Technical Service Bulletin

46 Squeal from front brakes

46 15 04 2039615/2 February 12, 2015. Supersedes Technical Service Bulletin Group 46 number 15-03 dated February 9, 2015 for reasons listed below.

Figure 1. Shims on back of front brake pads.

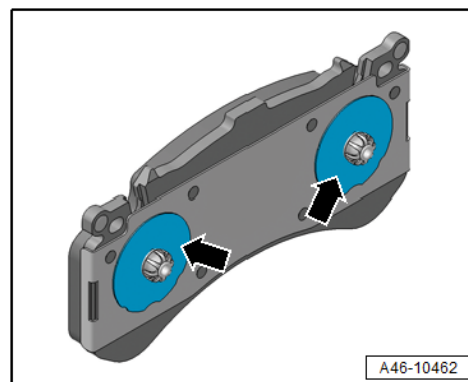
- Some vehicles may have two shims glued to the back of the front brake pads (Figure 1). **Do not** transfer these shims to the new pads.
- New brake pads have an adhesive backing that should be used to properly attach the pads to the caliper.
